Product Change Notification (PCN)

PCN #: 8C-2024

Date: August 19th, 2024

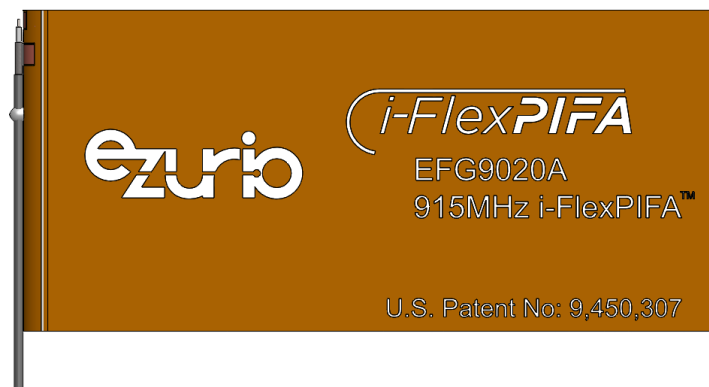
- The company name has been officially changed from Laird Connectivity to Ezurio. As a result, all product PCB Silkscreen labeling and packaging that previously displayed the Laird Connectivity logo will now feature the updated Ezurio logo. This change includes, but is not limited to:
 - Product labels
 - Product packaging

- Besides change in silkscreen to change the company logo from Laird Connectivity to Ezurio , there are no electrical RF implications for this change. There is no form, fit or functional changes.

- Revision is not printed on this antenna. Ezurio logo printed is a sign of the change.
